# SERVICE LETTER

No. 969

Piper Aircraft Corporation

Wing Tip Ground Strap Installation

VIEW LOOKING DOWN  
(Left Side Shown, Right Side Opposite)

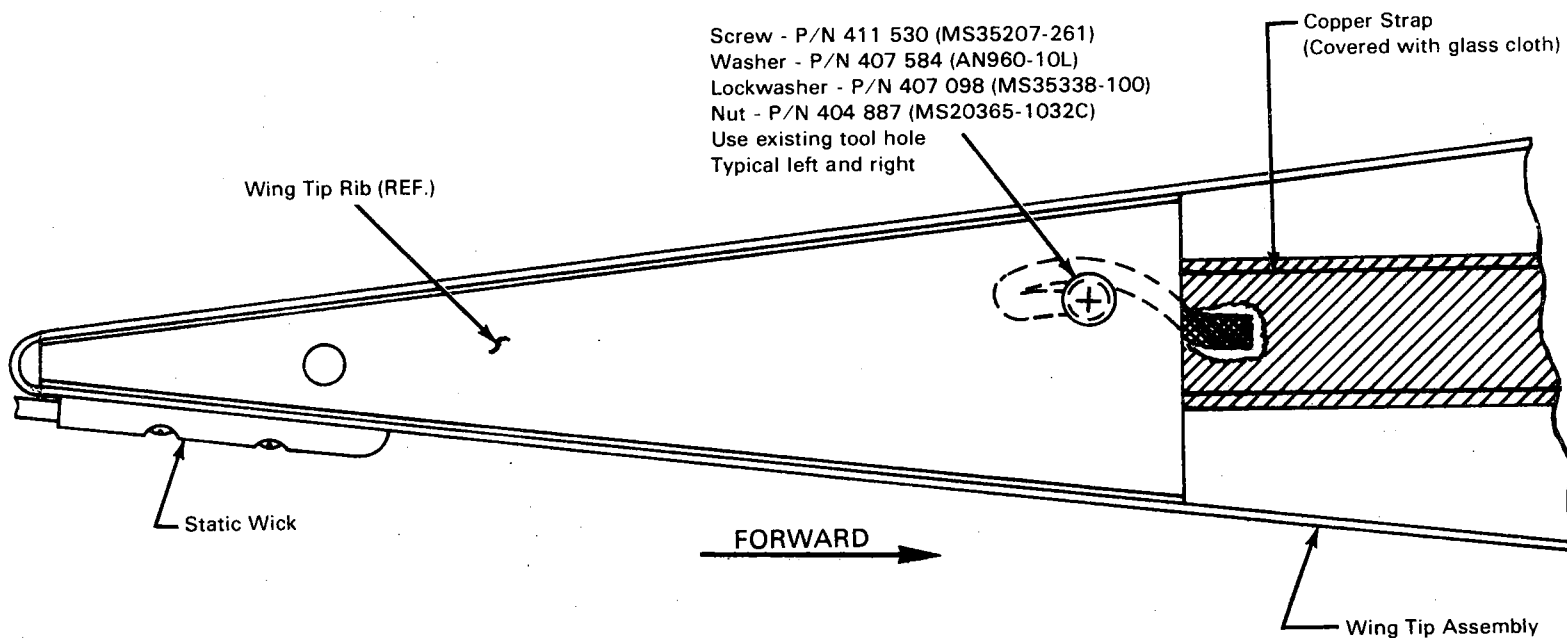
1. Remove both wing tips.
2. Reference Sketch A, fabricate and install in each wing tip a 6-inch length of 13/64 I.D. tin plated copper braid ground strap. Clean all paint from around both sides of the tooling hole in wing tip mounting rib, and alodine the bare aluminum prior to attaching the ground strap. Secure the ground strap to the rib using hardware as illustrated.

3. Inside of each wing tip, running chordwise, is a one inch wide copper lightning diverter strap held in place by a covering of glass cloth, approximately seven (7) inches forward of the wing tip trailing edge. Cut through the glass cloth to expose a small area of the diverter strap. Expose enough of the diverter strap to make a soldered connection to the copper braid. (Refer to Sketch A.)

4. Reinstall each wing tip. Make sure the wing tip lightning diverter bonding strap makes good metal to metal contact with the wing structure.
5. Perform a resistance check between the base of the wing tip static discharge wick and the outboard end of the aileron. The resistance should not be more than one (1) ohm.
